125-17-CA

1012 W CABARRUS STREET

APPLICATION FOR A CERTIFICATE OF APPROPRIATENESS – STAFF REPORT

Nature of Project: Installation of driveway; removal of tree; removal of site wall

PROPOSED SITE & TREE PROTECTION PLAN

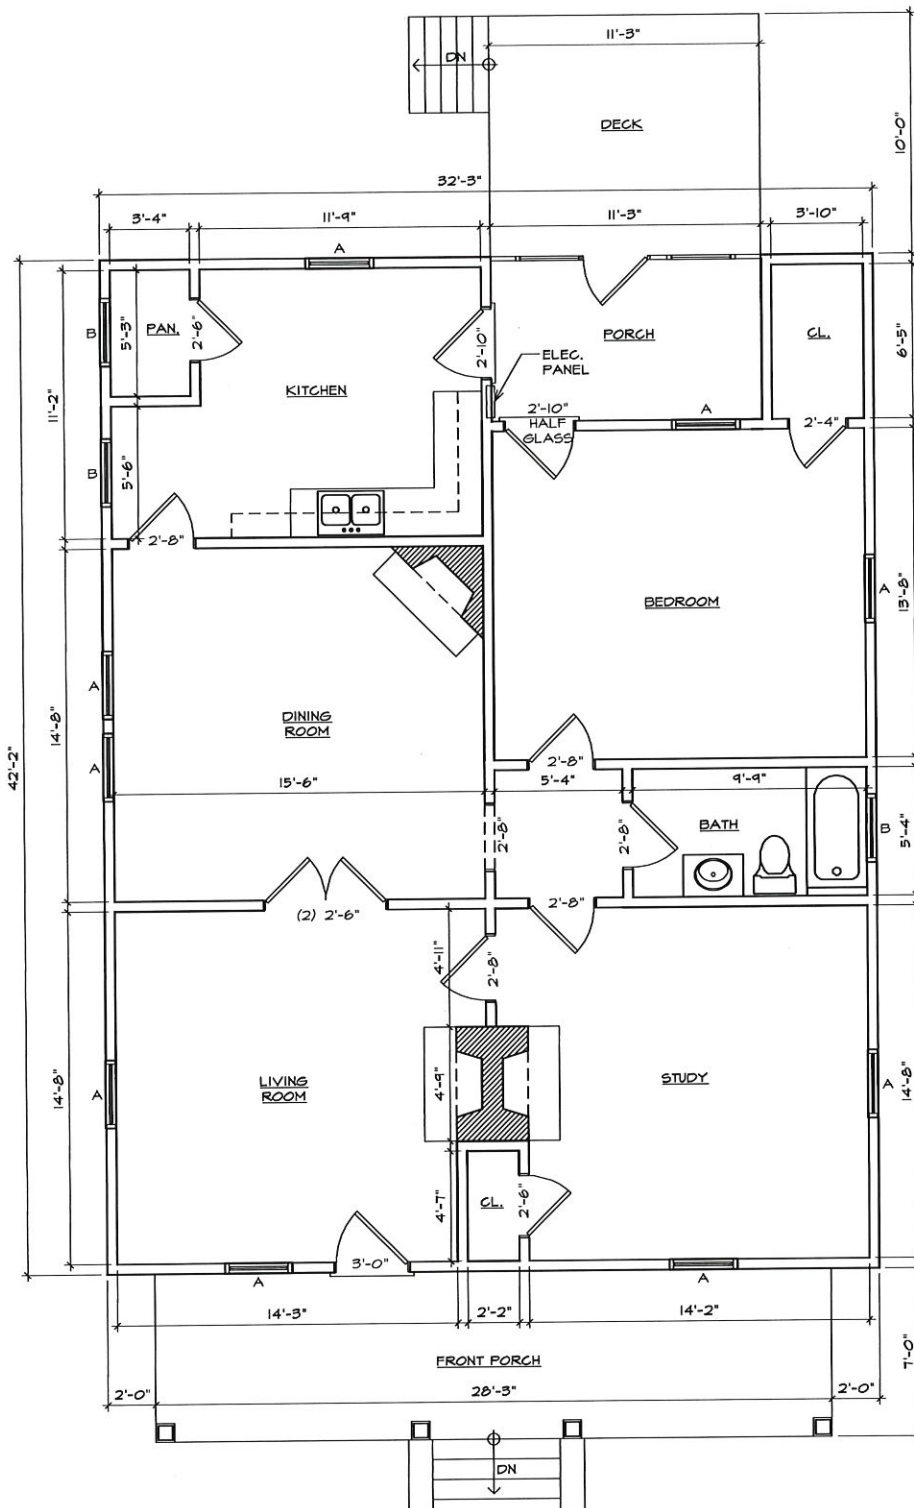
- 1* The property does not currently include a driveway. The proposal is to install an approximately 48' long gravel driveway with a new curb cut to the right of an existing power pole. No detailed drawing was provided to illustrate the design of the curb cut.

- 2* The driveway design has been revised to curve around the existing power pole in the utility strip. Although the driveway location on the south property line is a traditional location, the curved design around the power pole is atypical for the district.

- 1* A mature crape myrtle tree west of the existing front porch is proposed to be removed to allow for the installation of the driveway. The applicant proposes planting a 16' tall crape myrtle in the southeast corner of the front yard to replace it.

- 1. That the 365-day demolition delay be placed on the removal of the crape myrtle tree.
- 2. That details and specifications for the following be provided to and approved by staff prior to issuance of the blue placard for the driveway:
 - a. Driveway and curb cut design;
 - b. Walkway design and materials.

Staff suggests that the committee deny the driveway portion of the application.
